RENESAS TECHNICAL UPDATE

Product Category	MPU & MCU	Document No.	TN-16C-A207A/E	Rev.	1.00
Title	Errata to R32C/121 Group Hardware Manual		Information Category	Technical Notification	
Applicable Product	R32C/121 Group	Lot No.	Reference Document	R32C/121 Group Hardware Manual Rev. 1.10 (REJ09B0477-0110)

This document describes corrections to the R32C/121 Group Hardware Manual, Rev. 1.10.
The corrections are indicated in red in the list below.

Figure 7.1 Clock Generation Circuitry

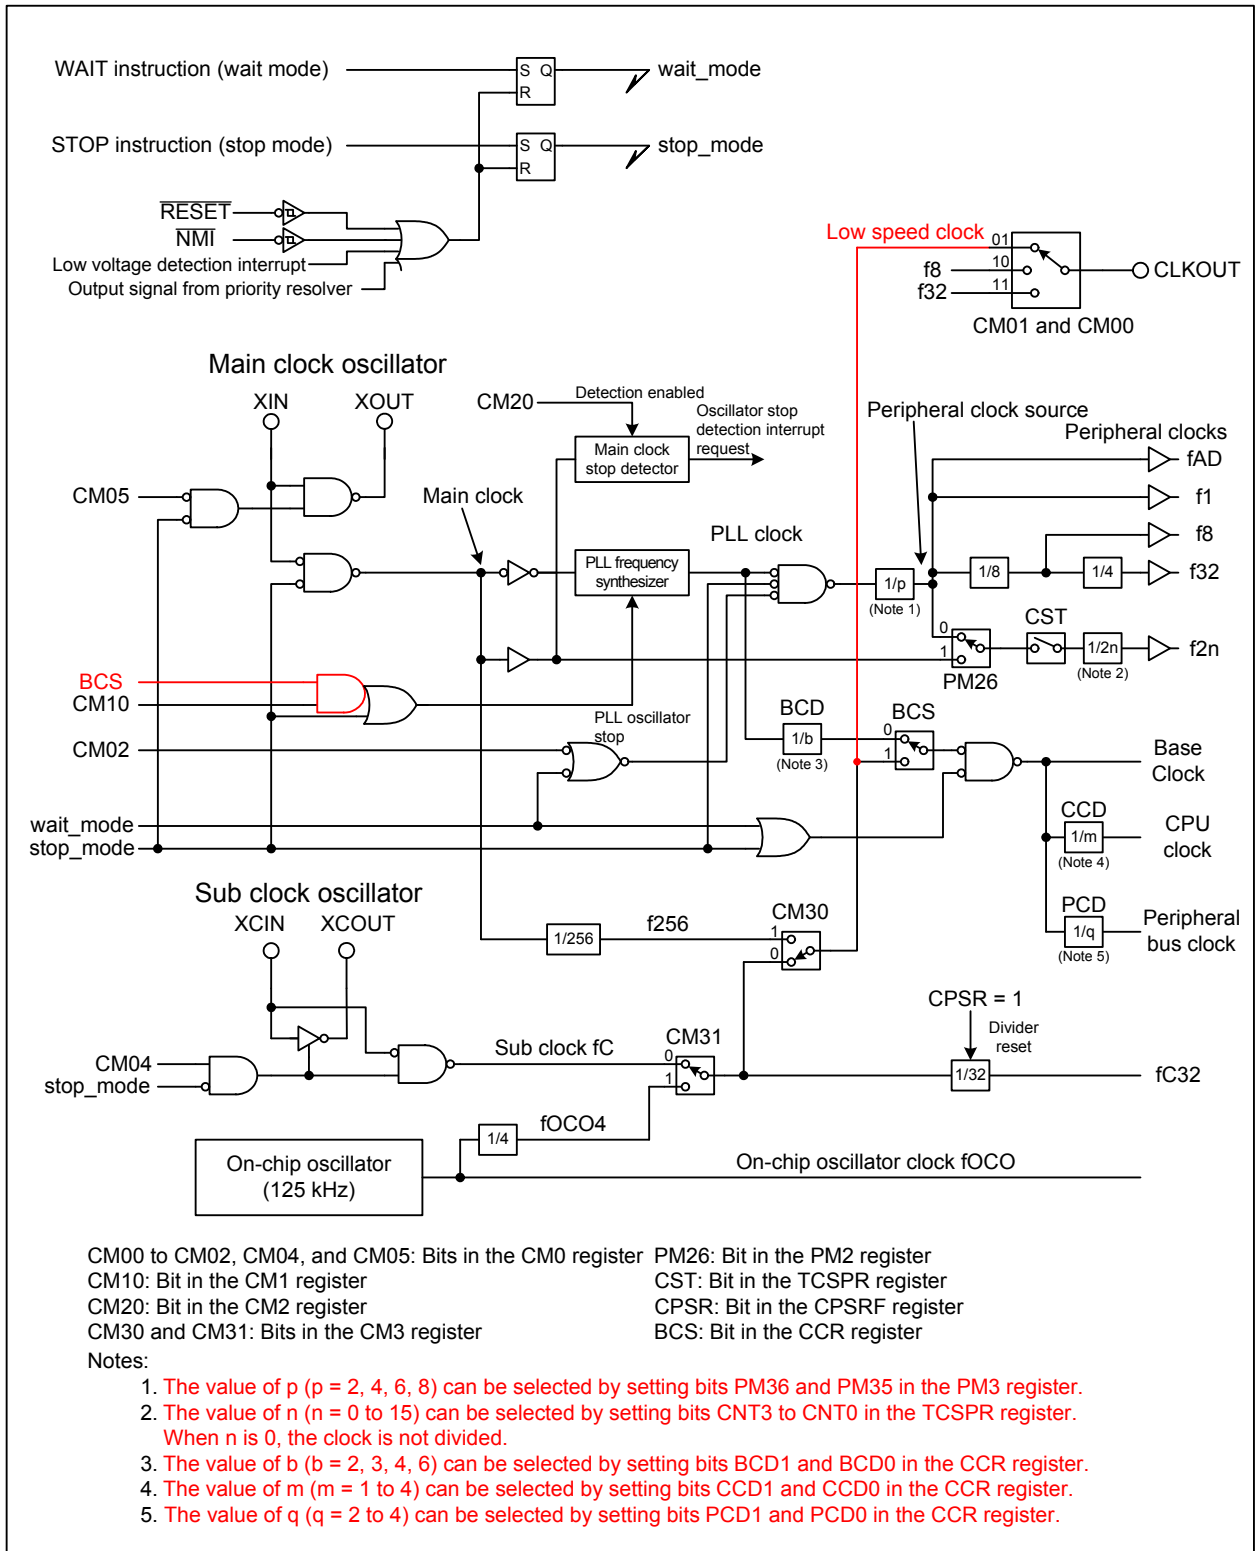
•Page 87 of 604, Figure 7.1 is corrected as follows:

Figure 10.8 Priority Resolver

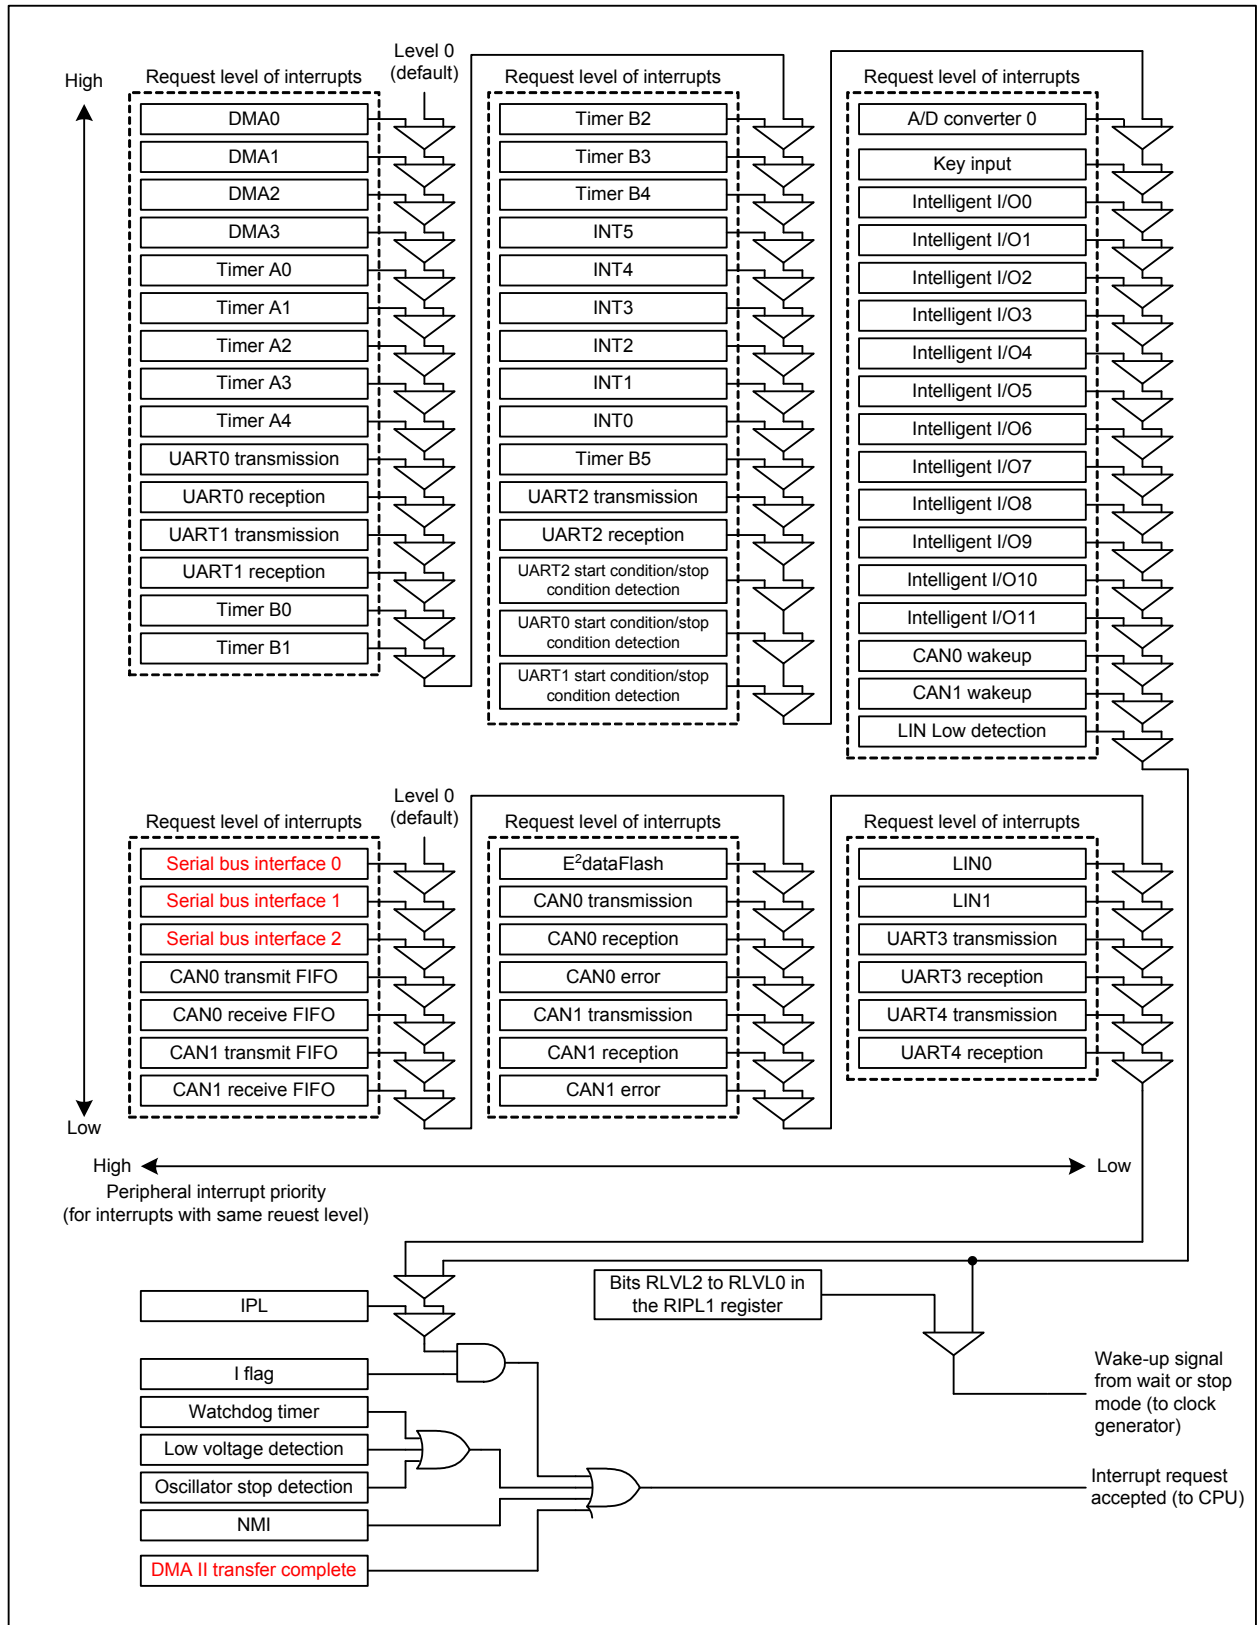
•Page 139 of 604, Figure 10.8 is corrected as follows:

(Description "Bits RLVL2 to RLVL0 in the RIPL2 register" and associated signal lines are deleted from Figure 10.8)

Figure 15.2 Timer B Configuration

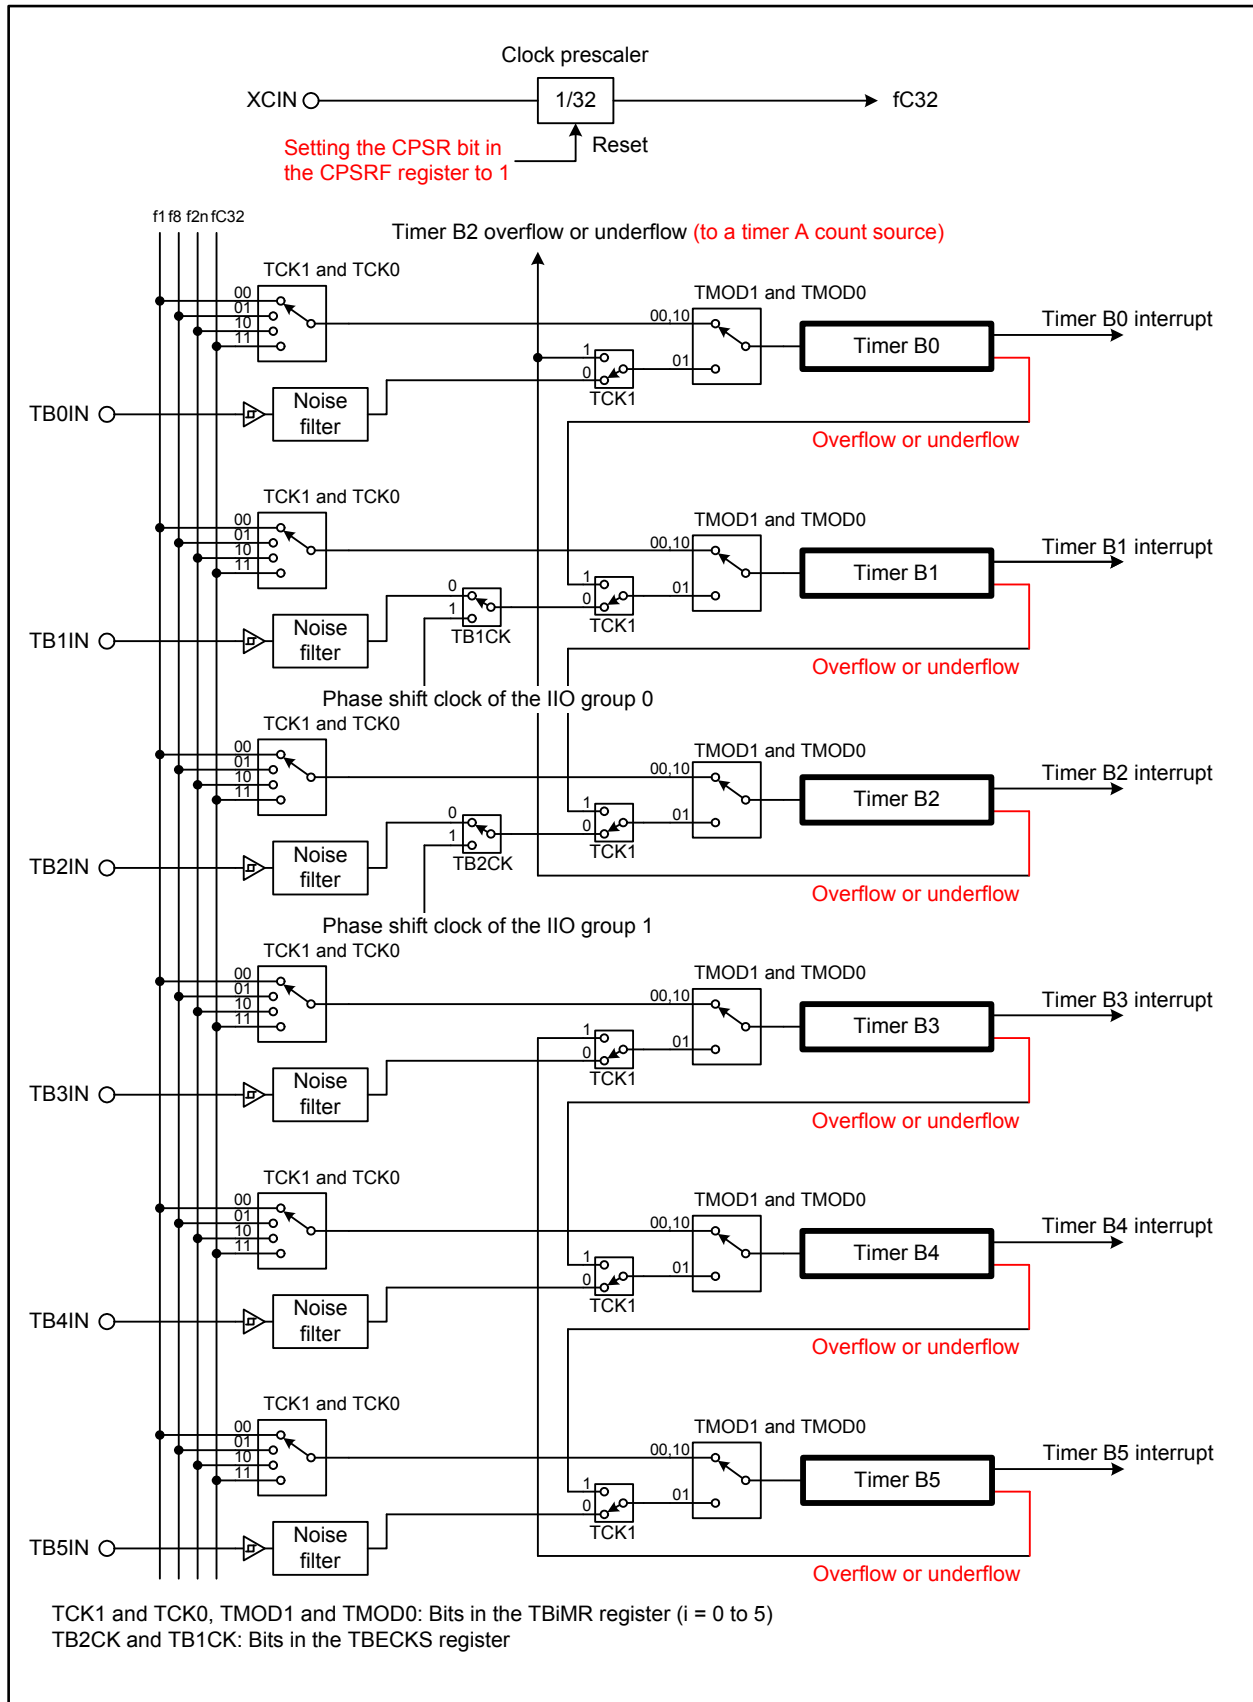
•Page 179 of 604, Figure 15.2 is corrected as follows:

Figure 20.1 CRC Calculator Block Diagram

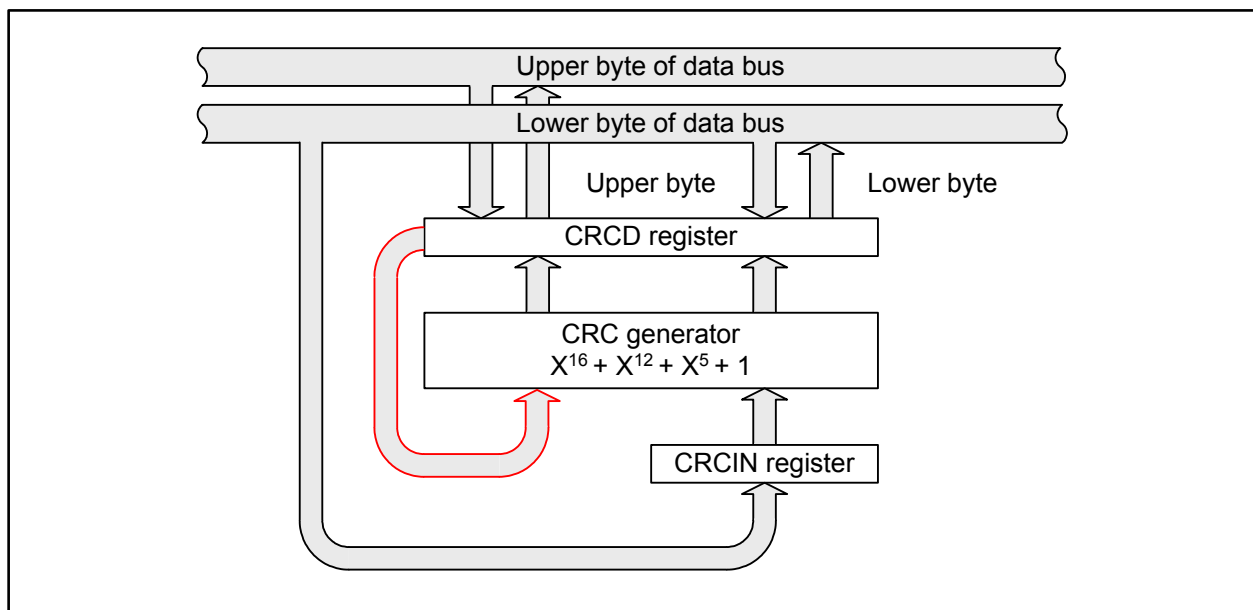
- Page 304 of 604, Figure 20.1 is corrected as follows:

Figure 24.30 Example of Setting Before Transition to Wait Mode

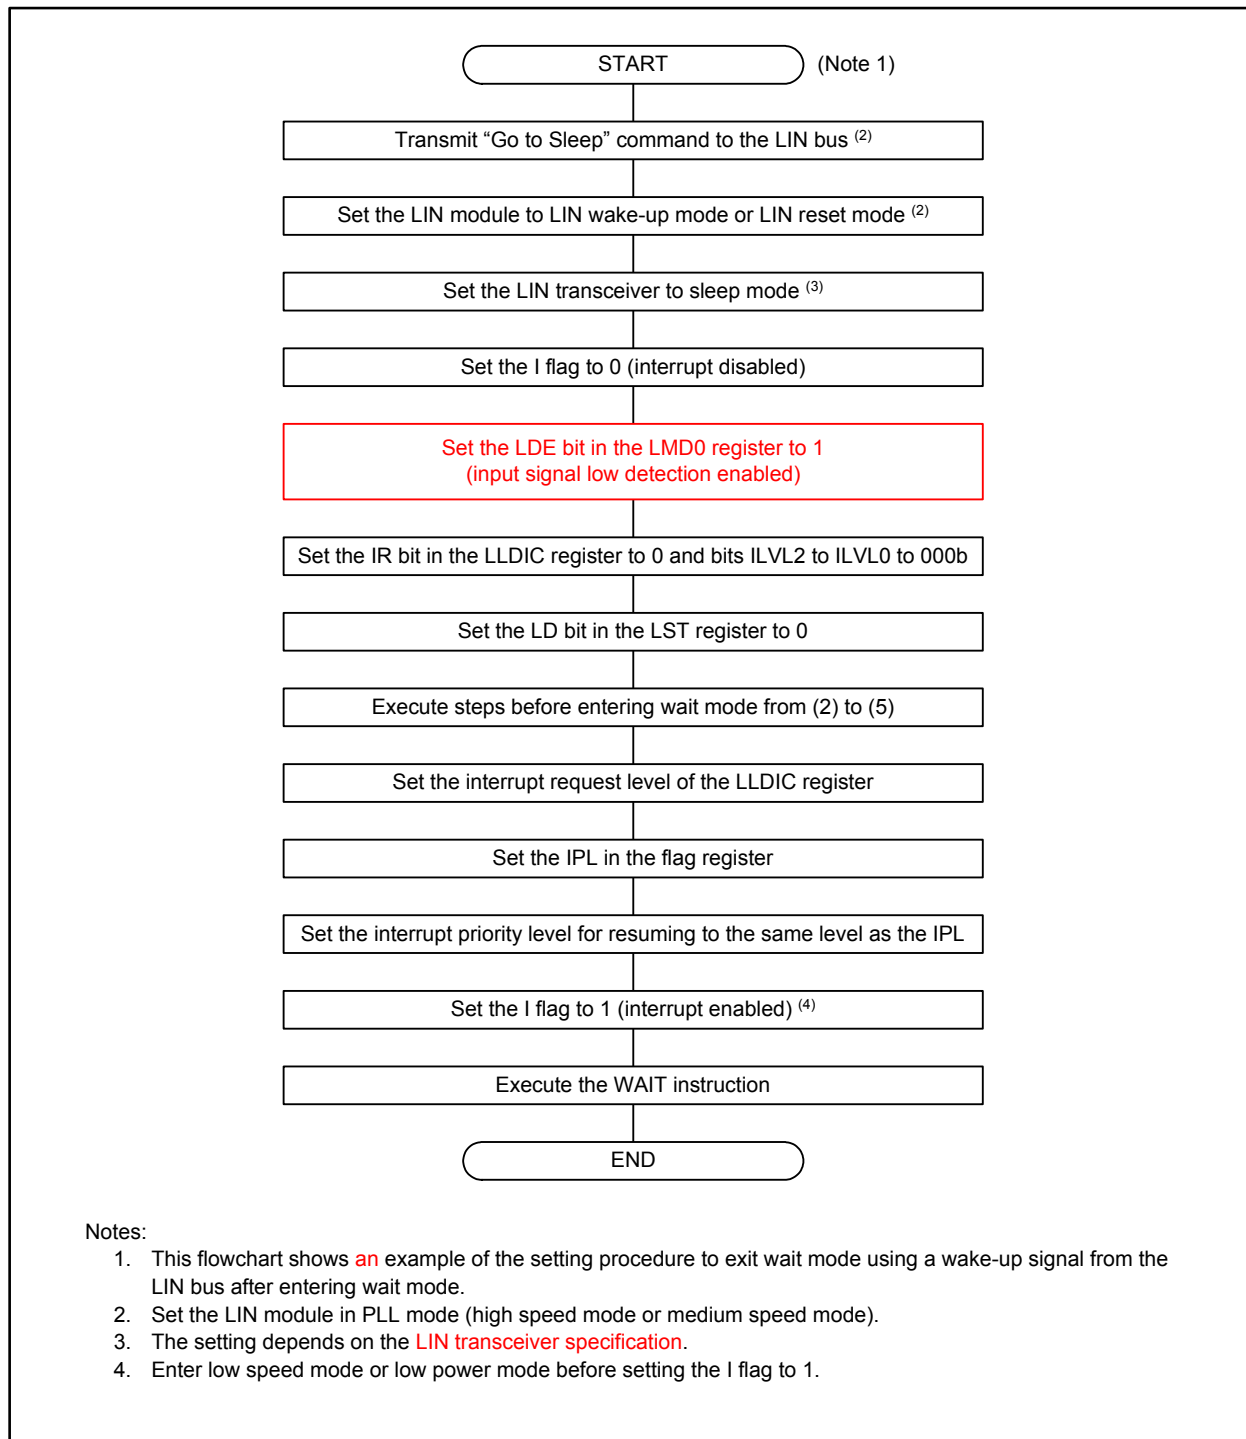
•Page 409 of 604, Figure 24.30 is corrected as follows:

Figure 24.32 LINj Interrupt Block Diagram (j = 0, 1)

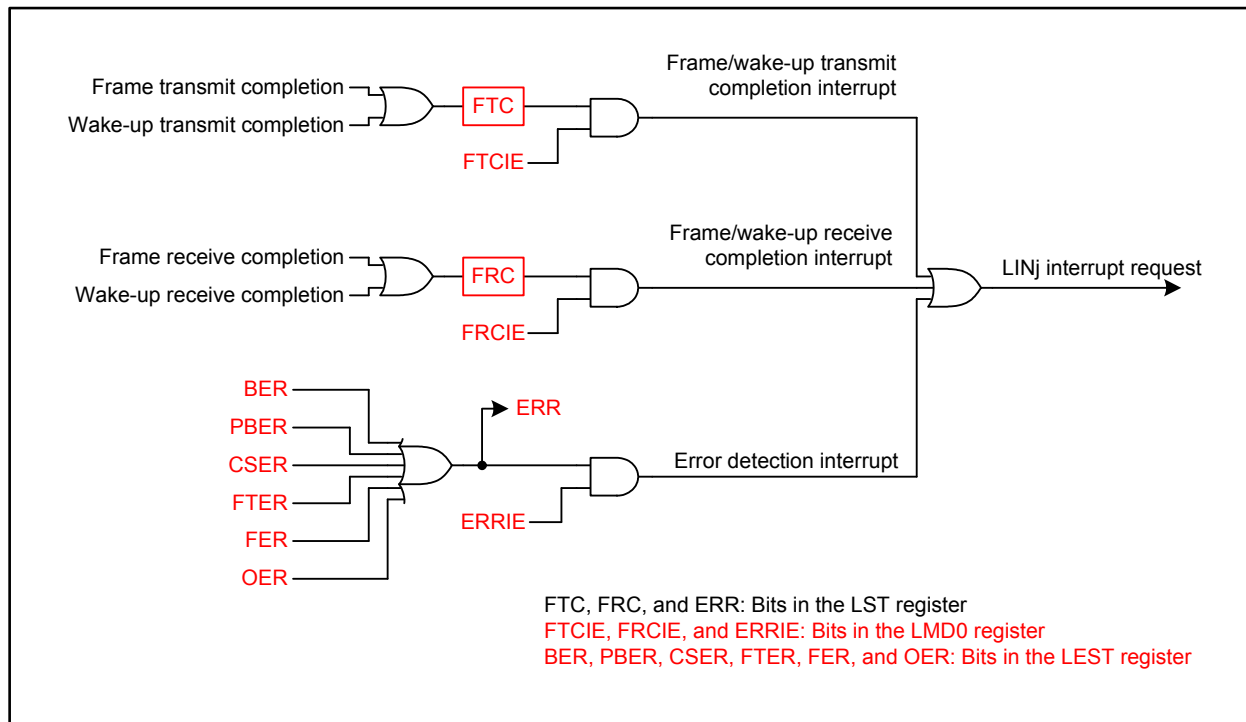
•Page 413 of 604, Figure 24.32 is corrected as follows:

Figure 24.33 LIN Low Detection Interrupt Block Diagram

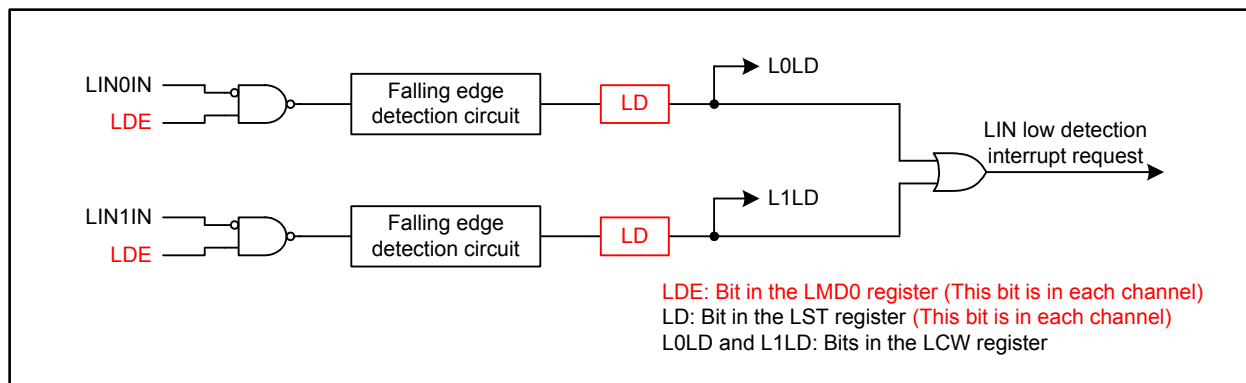
•Page 413 of 604, Figure 24.33 is corrected as follows:

Figure 26.1 Typical I/O Pin Block Diagram (i = 0 to 10; j = 0 to 7)

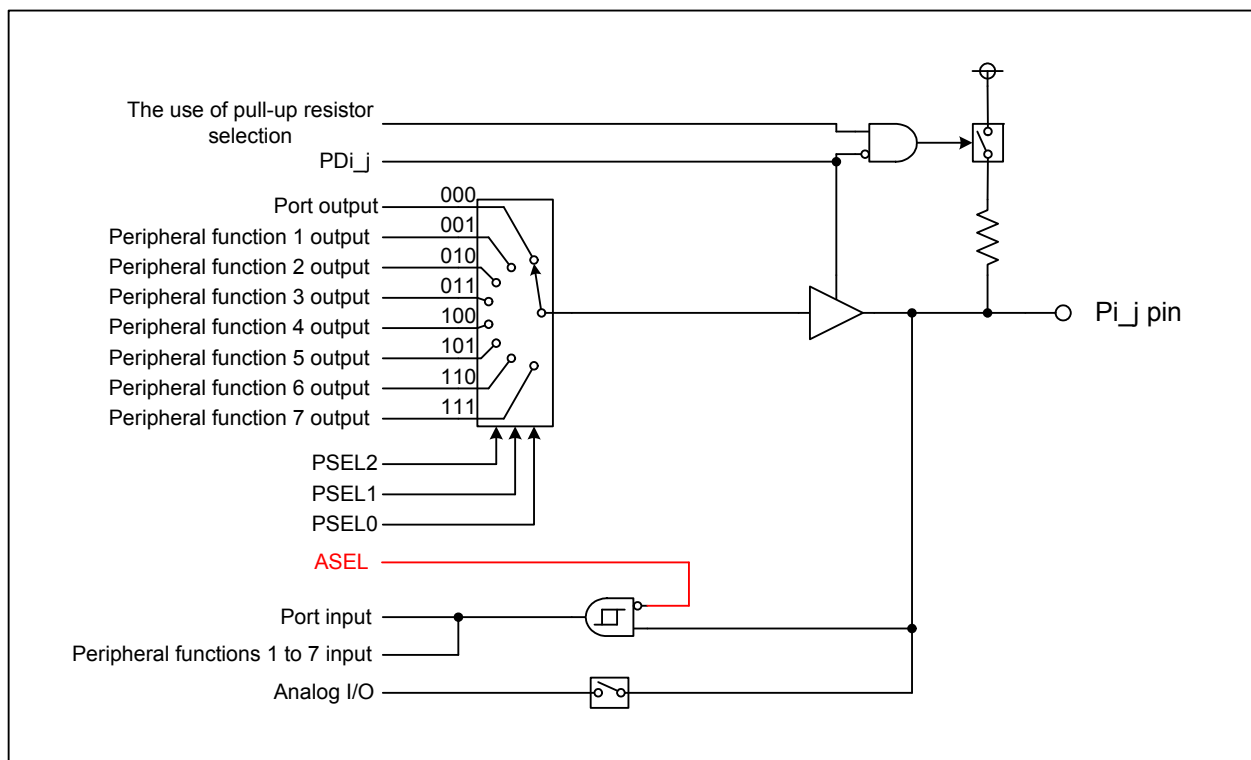
- Page 483 of 604, Figure 26.1 is corrected as follows (refer to TN_16C_A198A/E):
